ENV_16-02637-CONDIT_07

Application 16/02637/CONDIT - Phoenix Gym - Discharge of Condition 6 of permission 15/02107

3D analysis of Phoenix Gym SUDS submission for Condition 6

Based on document 667769-REP-SBU-DS - 23rd September 2016

3D analysis of Phoenix Gym SUDS submission for Condition 6

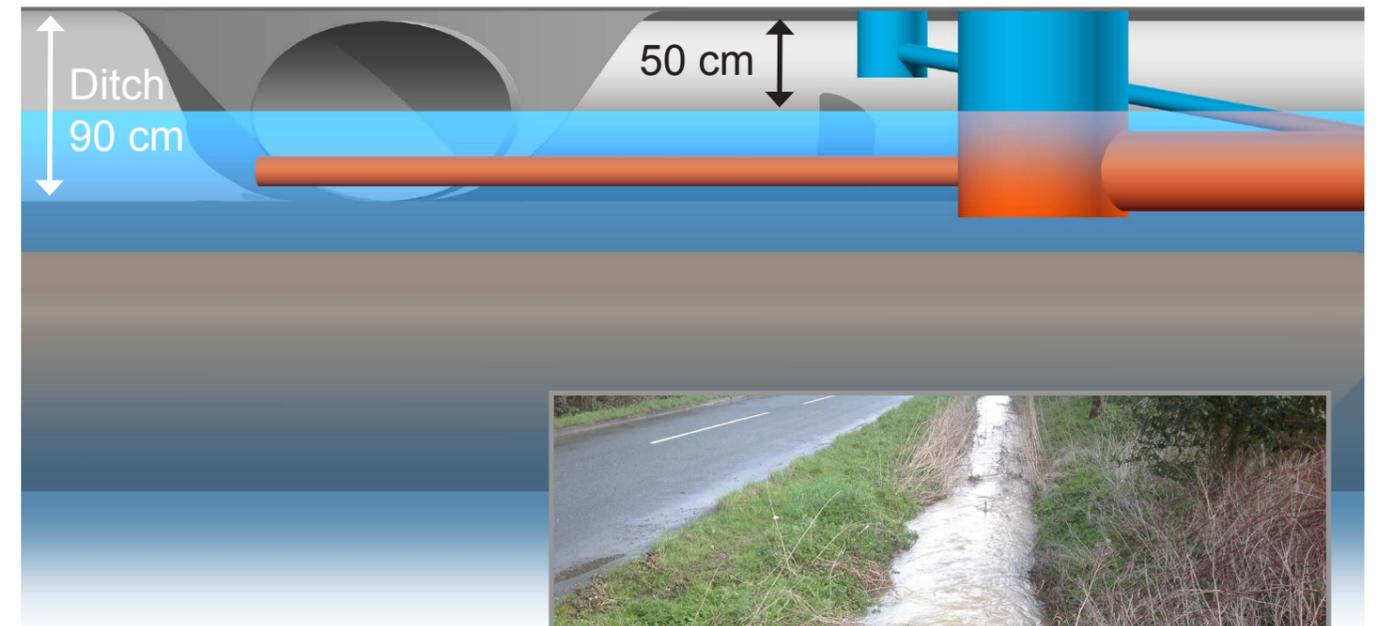
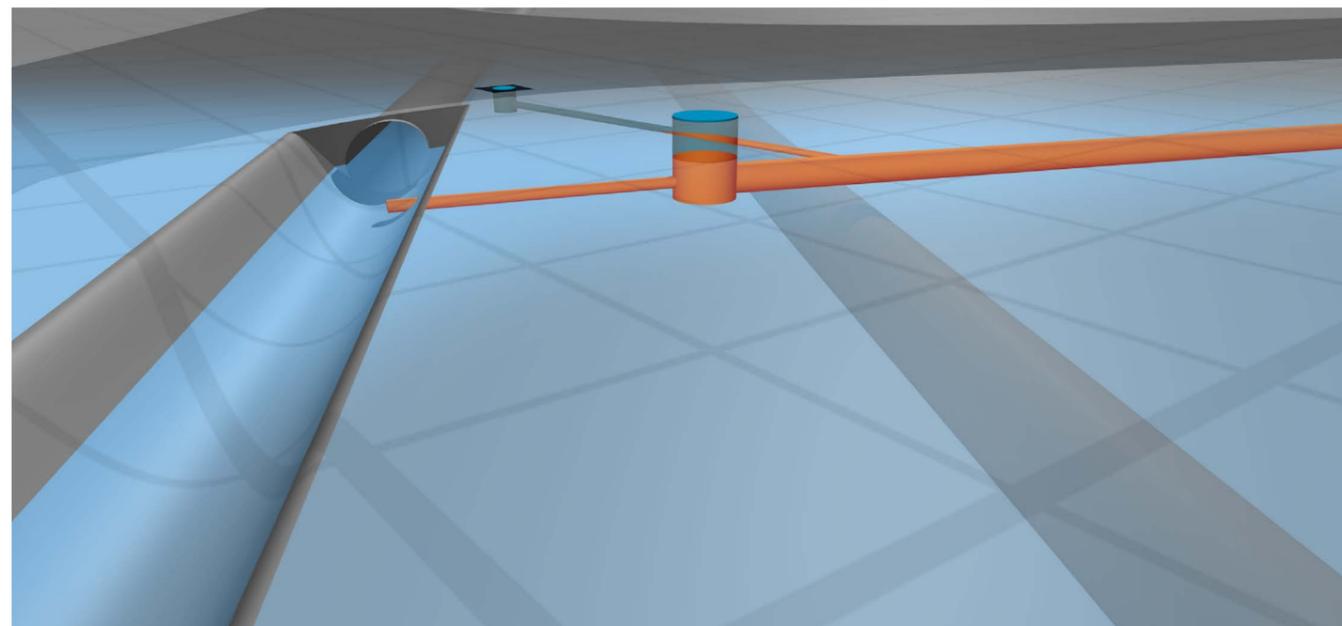
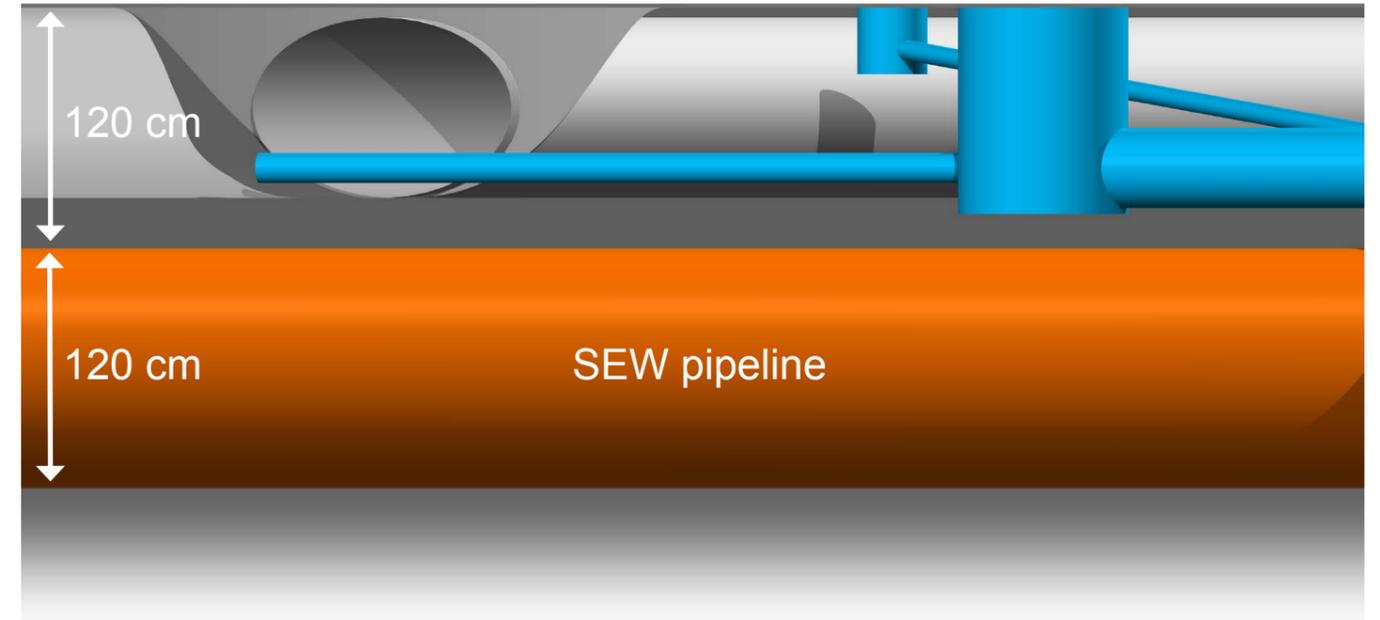
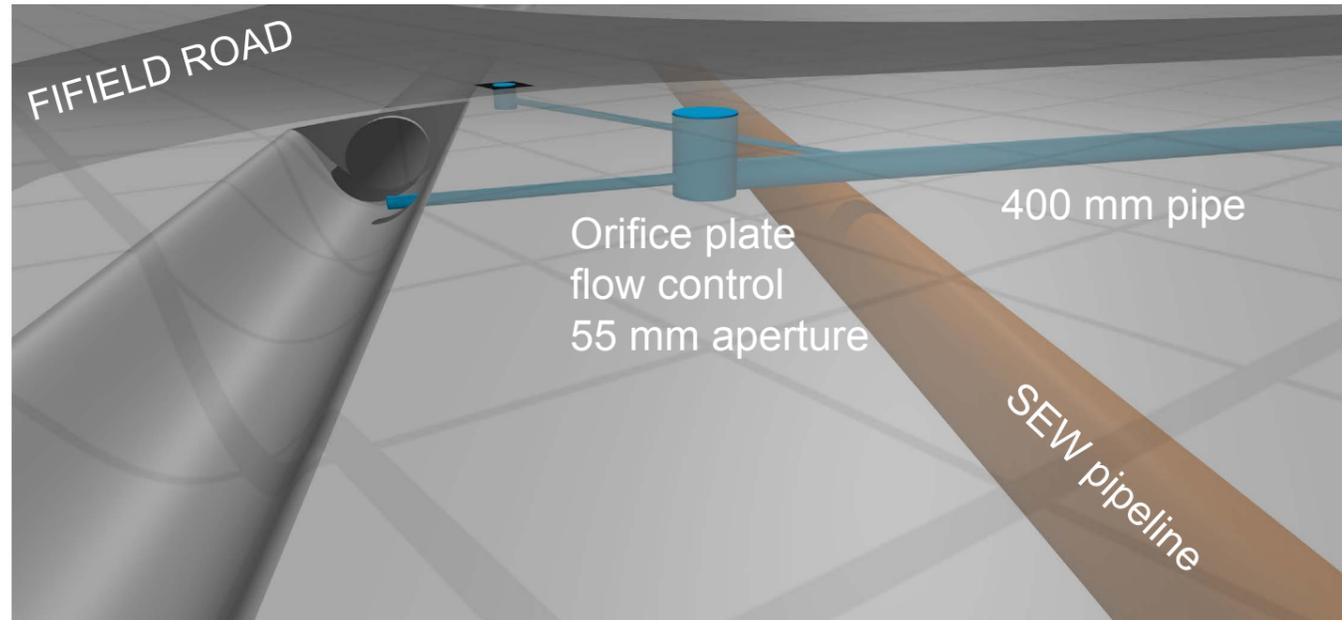
Capacity in wet season with water table level at -50 cm

79.37 m³ Total lost capacity below -50 cm

405.28 m³ Total capacity in wet season

0.00 m³ Capacity when ditch is full !

Swale : 316.32 - 71.85 m³

Bottom 40 cm will already be filled reducing capacity to **244.47 m³**

Pipe and 2 chambers : 6.77 - 6.18 m³

The top of the 400 mm pipe will be 100 mm below the -500 mm water table level, reducing capacity to only **0.59 m³**.

These and their associated 150 mm pipes will remain 200 mm above water table level at -500 mm. But the 4 silt traps will each have the lower 700 mm filled with water, losing **0.54 m³** of capacity.

This is seen to be about 5.5 bricks below surface. So, with mortar, approx **-42 cm**.
